PRELIMINARY LAND DEVELOPMENT PLANS FOR CITY VIEW

WORCESTER TOWNSHIP, MONTGOMERY COUNTY, PENNSYLVANIA

BT WORCESTER, LLC
CITY VIEW - APN #67-00-01606-001
2974 GERMANTOWN PIKE, WORCESTER TOWNSHIP,
MONTGOMERY COUNTY, COMMONWEALTH OF PENNSYLVANIA
COVER SHEET

BT WORCESTER, LLC
CITY VIEW - APN #67-00-01606-001
 2974 GERMAN TOWN PIKE, WORCESTER TOWNSHIP,
 MONTGOMERY COUNTY, COMMONWEALTH OF PENNSYLVANIA
EXISTING FEATURES PLAN

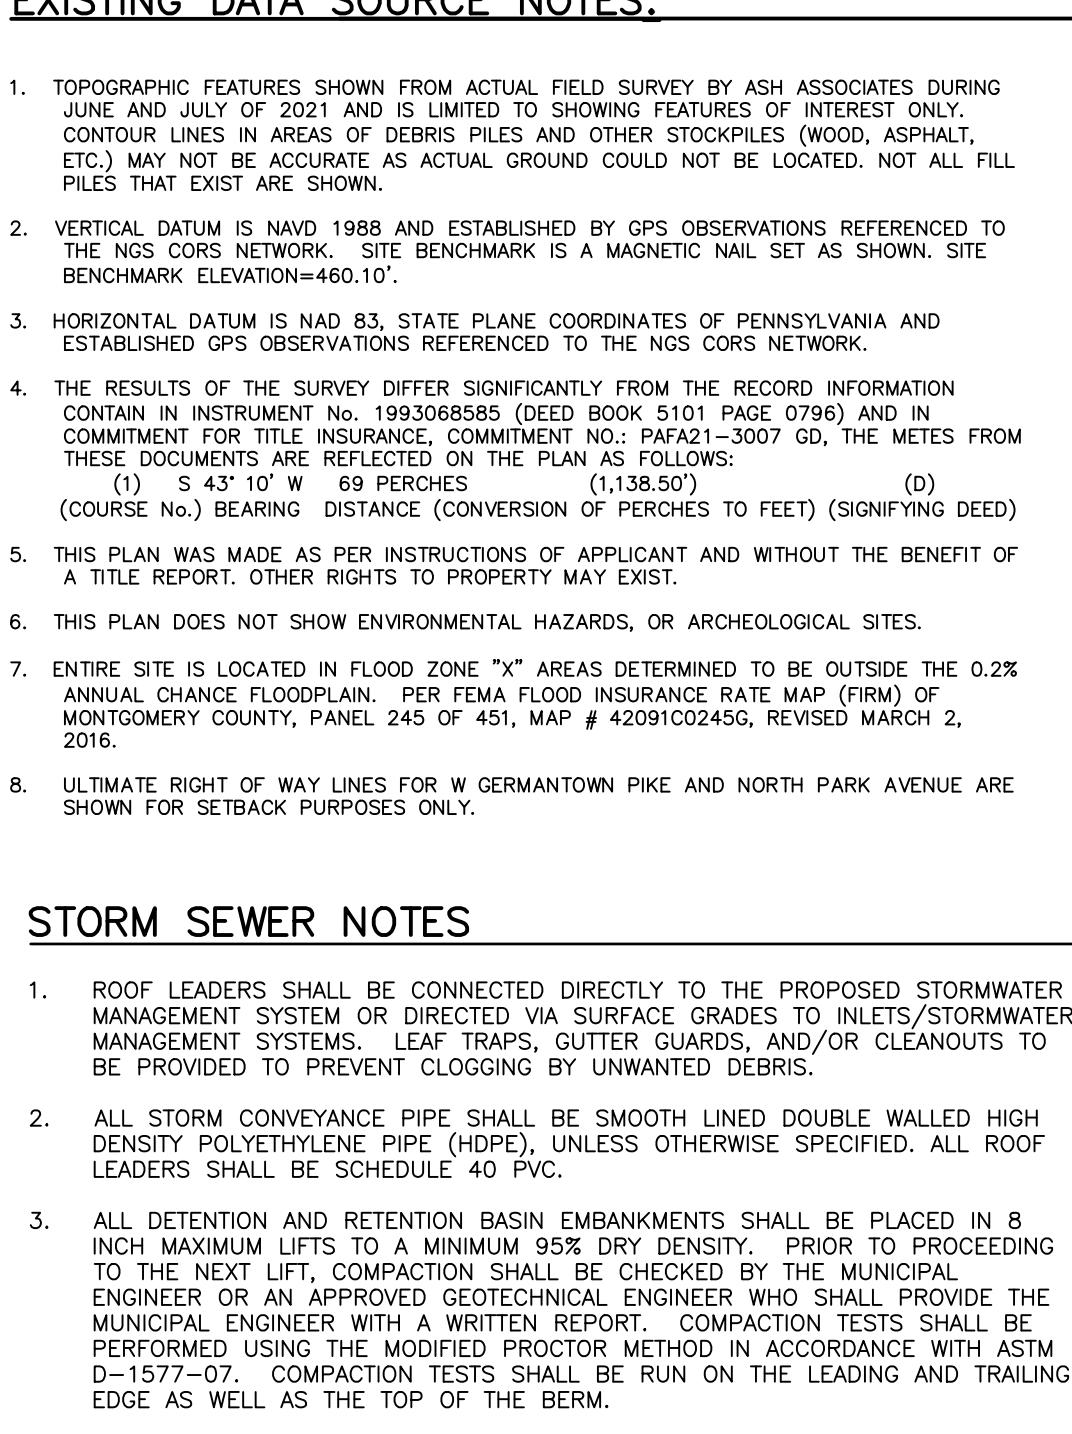
14. The Existing Feature plan, Sheet 3, indicates that a wooden fence separates the subject property from Parcel 43-00-02206-14-5 but the note on sheets 7 and 8 states chain link. This discrepancy must be addressed.

DESIGNED BY CGG/JPK/ROP	DRAWING DET-2
CHECKED BY DS	SHEET
DRAWN BY PG/SR/ROP	21
DATE 1/27/22	OF 34
SCALE AS NOTED	
PROJ. NO. BET00056

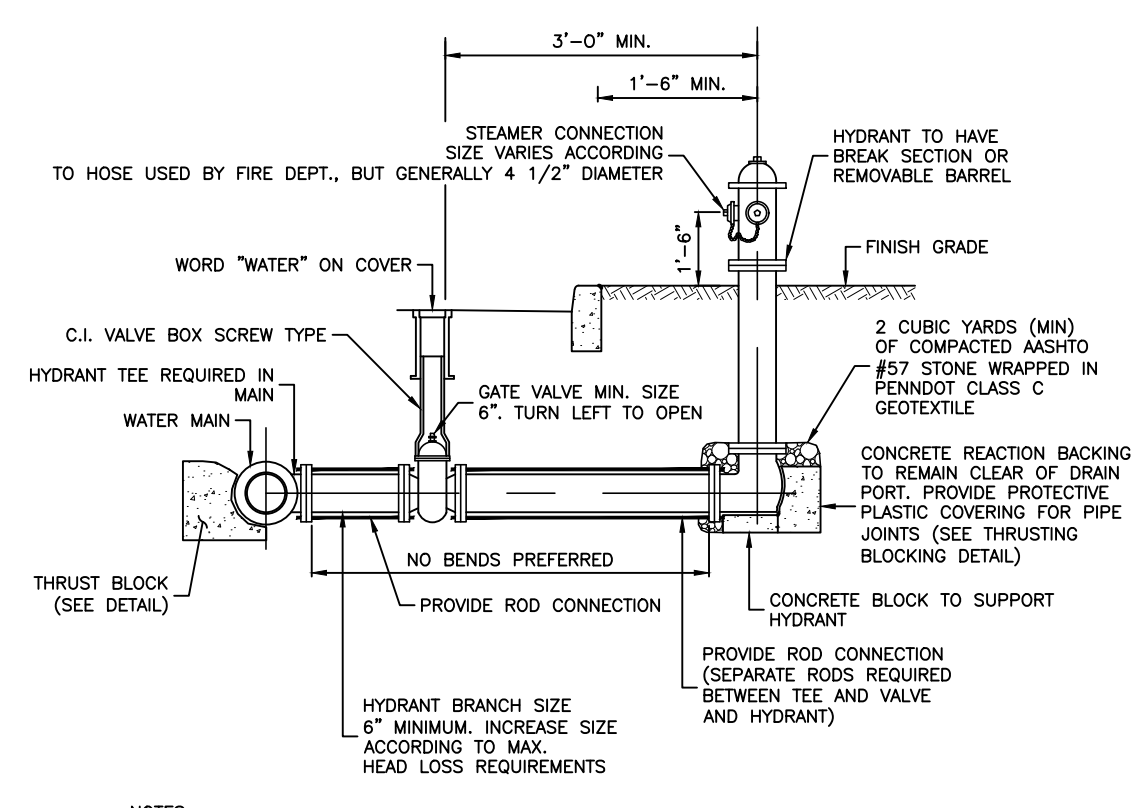
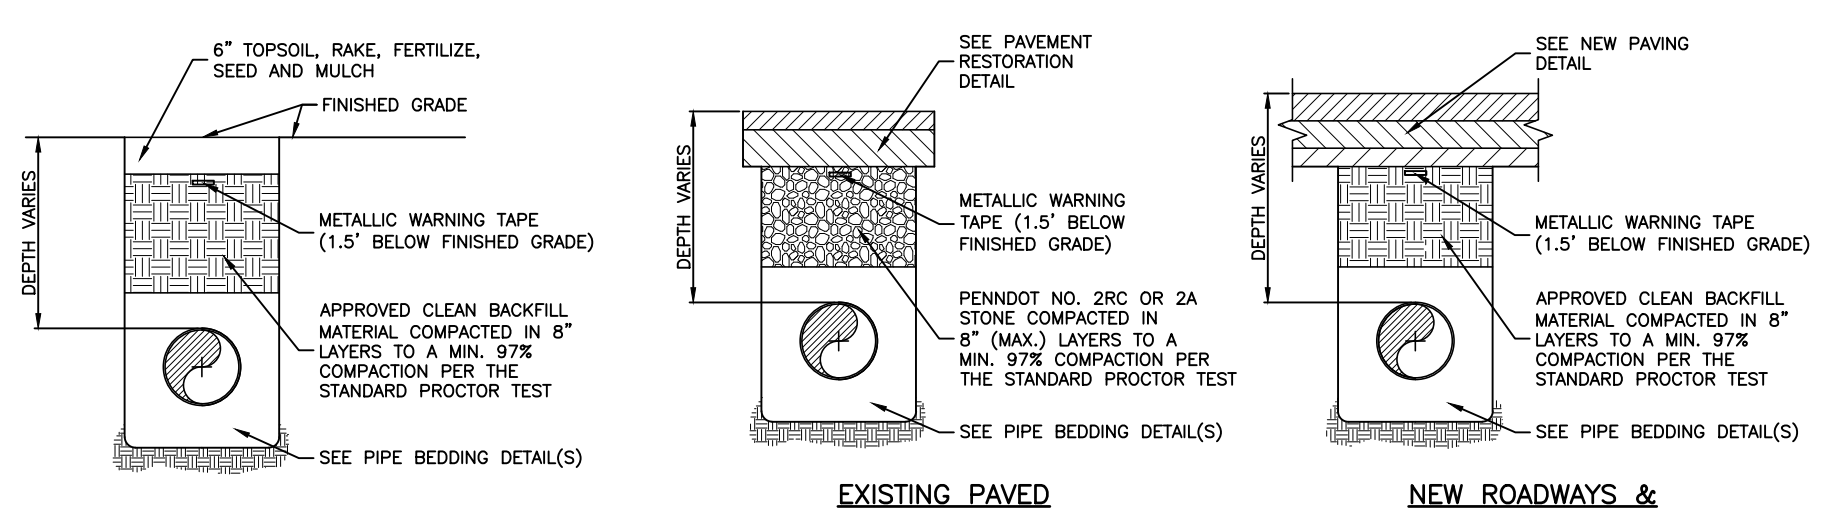
15. A trash enclosure detail is provided on Sheet 21 but the location of the enclosure could not be found on the plans.

16. A 12-foot high Emergency Gate detail is shown on the Sheet 21 but the plans do not indicate 12-foot high fence or gate. Please note that fencing can be no higher than 6-feet per Z.O. 150-182.

T&M Response: The detail has been removed from the plans. Refer to Drawing DET-2, Construction Details.
